MEETING DATE: February 25, 2026
TO: Planning Commission
STAFF ORIGINATOR: Steven Gilmore, AICP, Assistant Community Development Director
AGENDA ITEM: PUBLIC HEARING - Hidden Creek South Preliminary Plat and Planned Unit Development
60-Day Deadline: April 21, 2026

Headwaters Land Group, represented by Mr. John Dobbs, has submitted applications for a Preliminary Plat and Planned Unit Development (PUD) Amendment for Hidden Creek South. The subject property consists of approximately 56.52 gross acres located south of Headwaters Parkway within the Headwaters Master Planned Unit Development (PUD) area.

We provide the following comments for the proposed improvements:

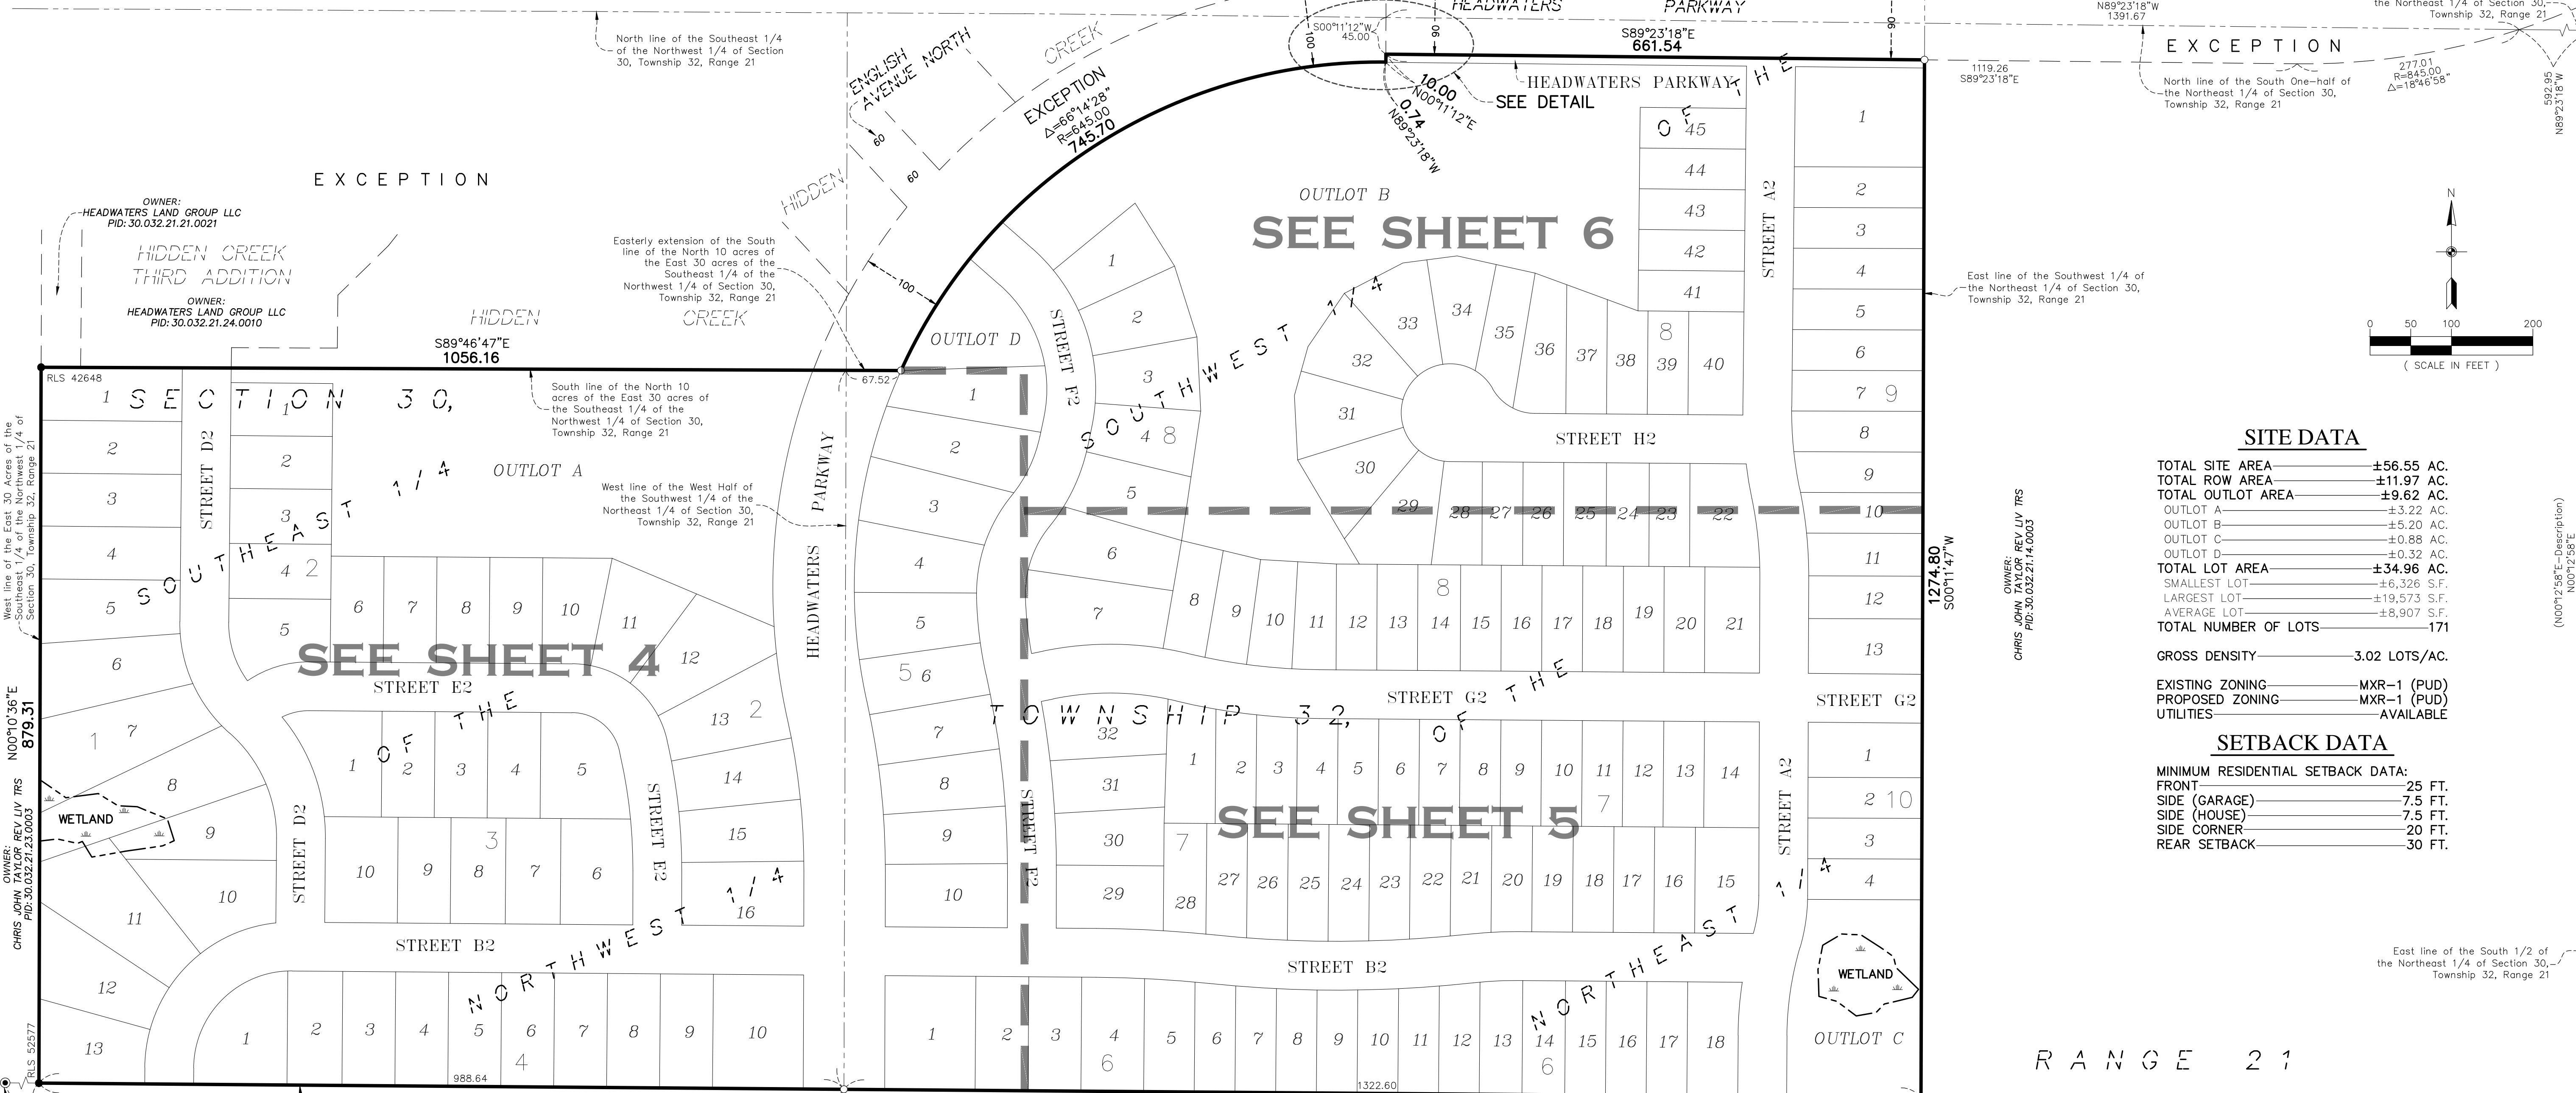
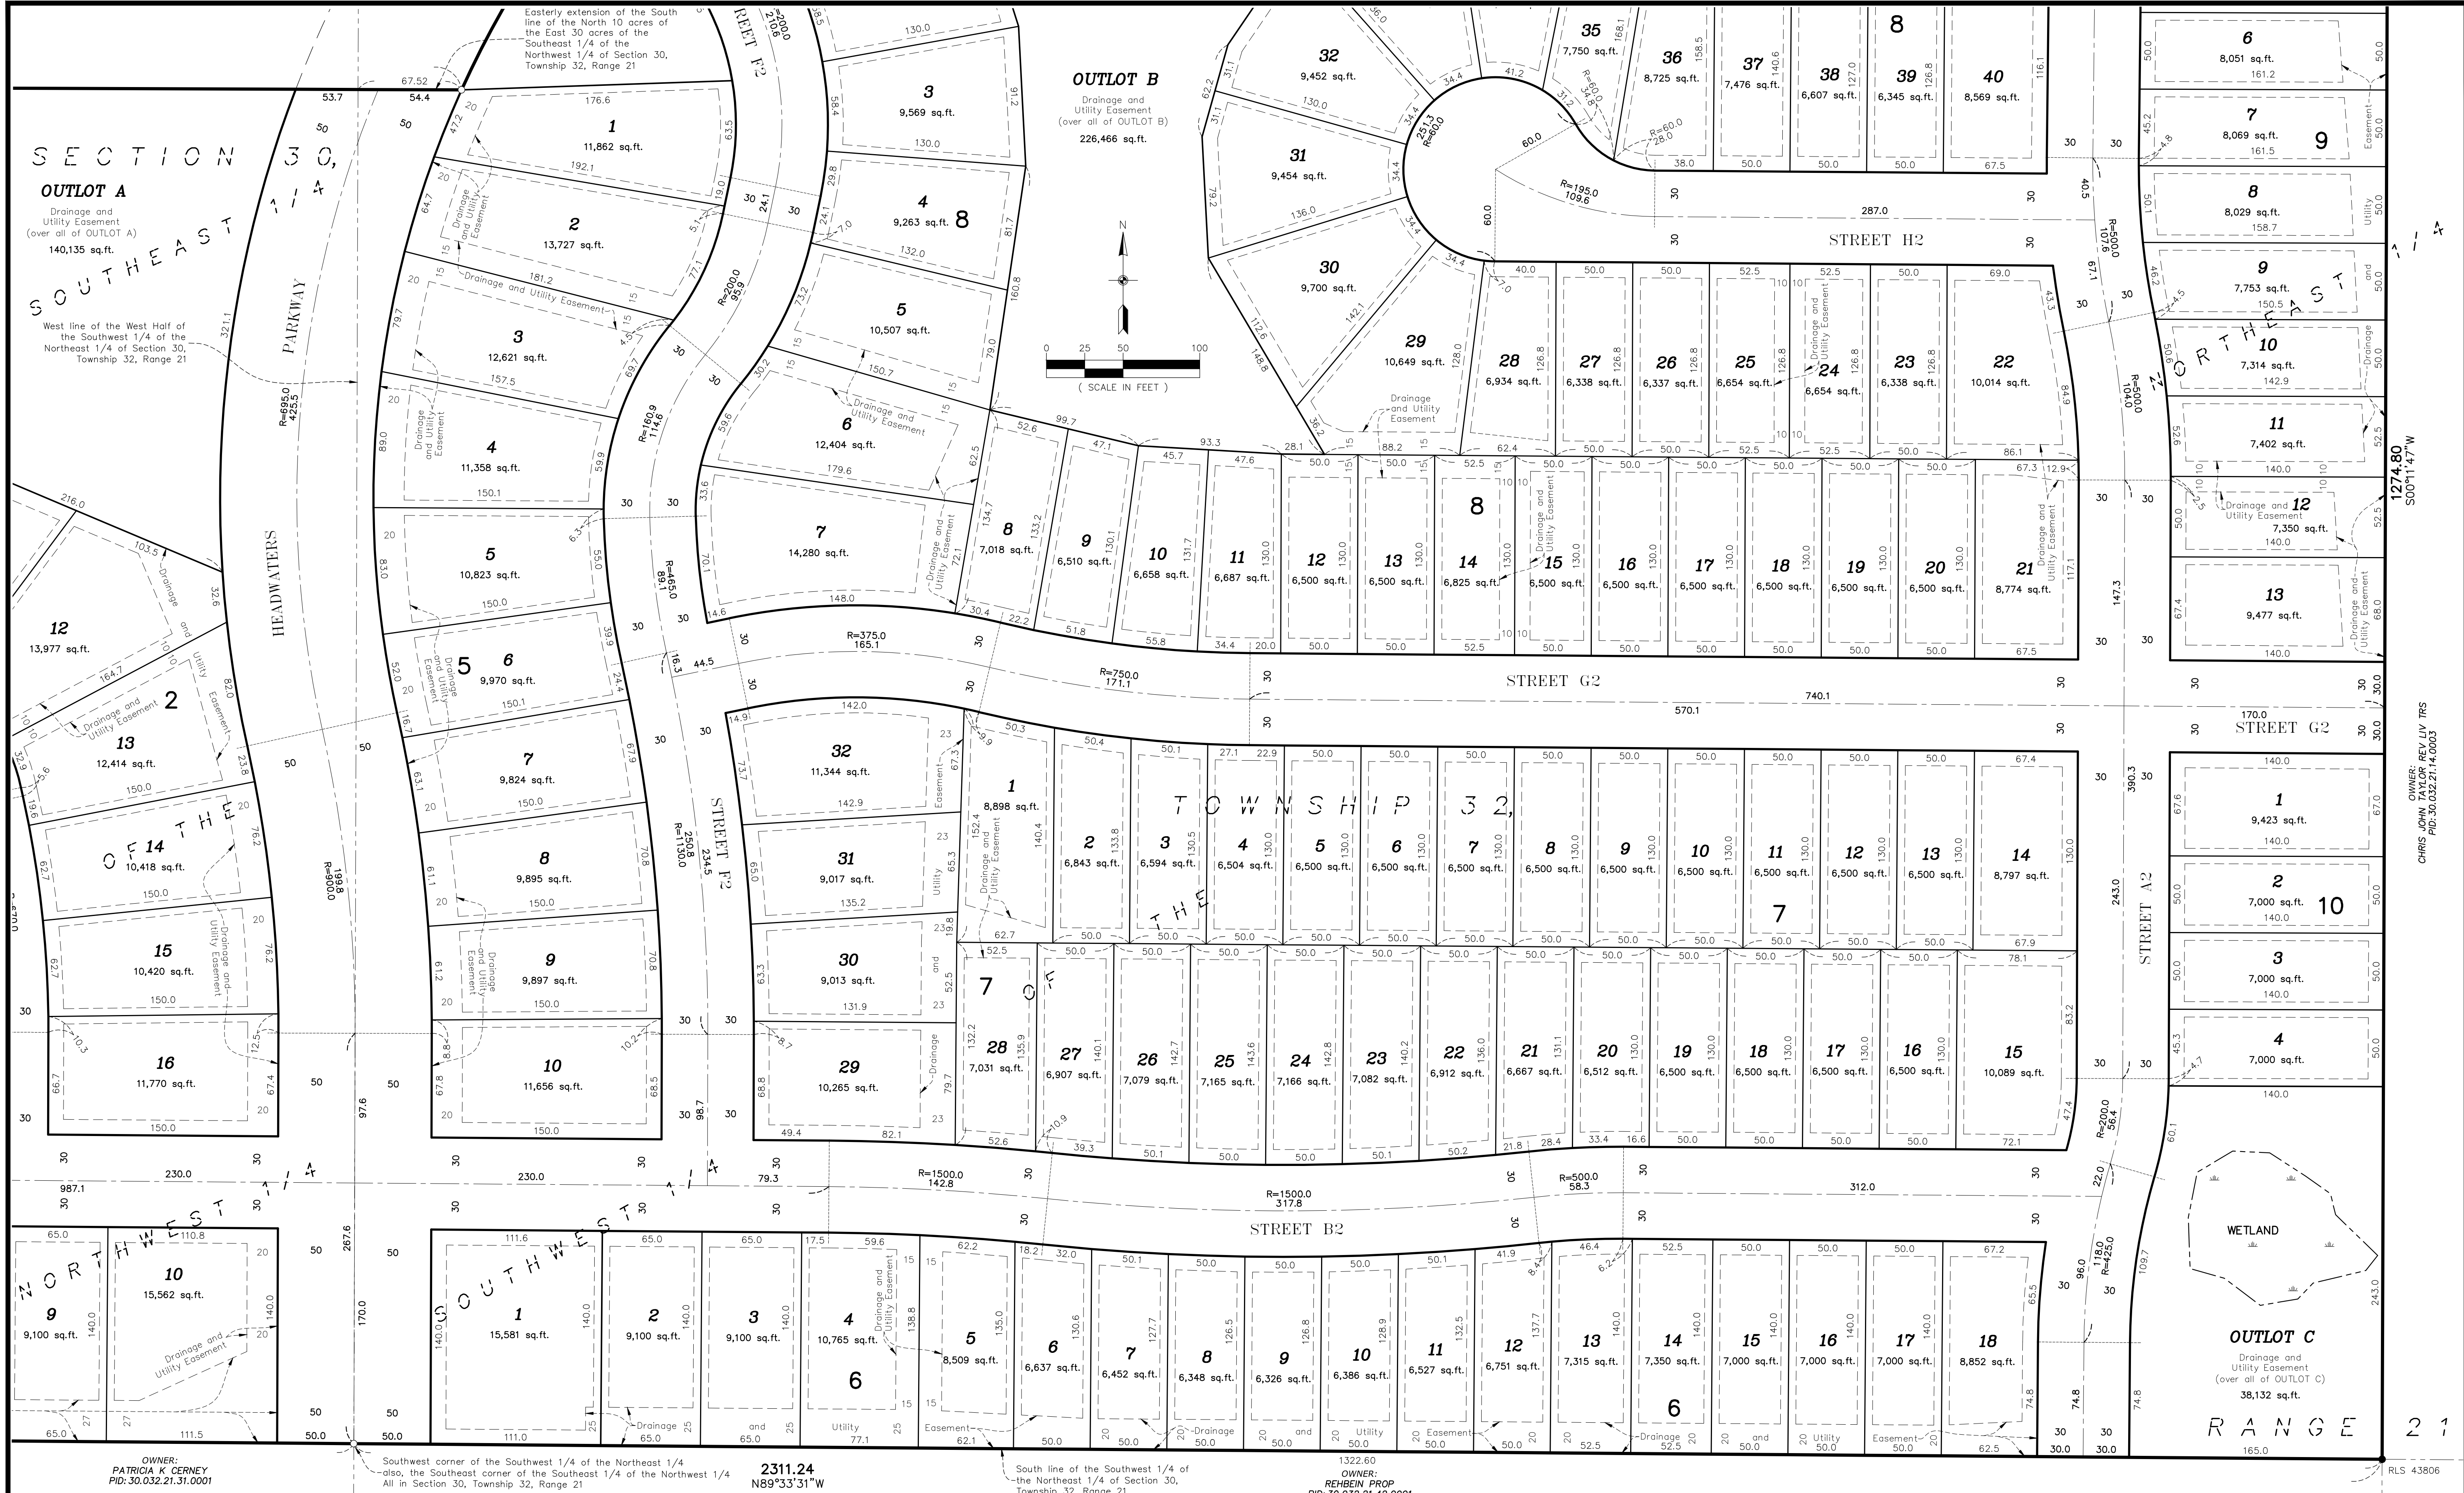
15. Show Legend and Lot Easement Detail on sheet 3 on sheets 4-6 as well.
16. Headwaters Parkway minimum centerline radius is 700', revise accordingly.
17. Local streets minimum centerline radius is 100', revise Street E2 accordingly.

18. Lot 1, Block 9 drainage and utility easement differs from utility and grading plans, revise.
19. The area contained within the 100-yr high water level (HWL) of stormwater ponds shall be excluded from parkland dedication areas per City Code section 152.091.
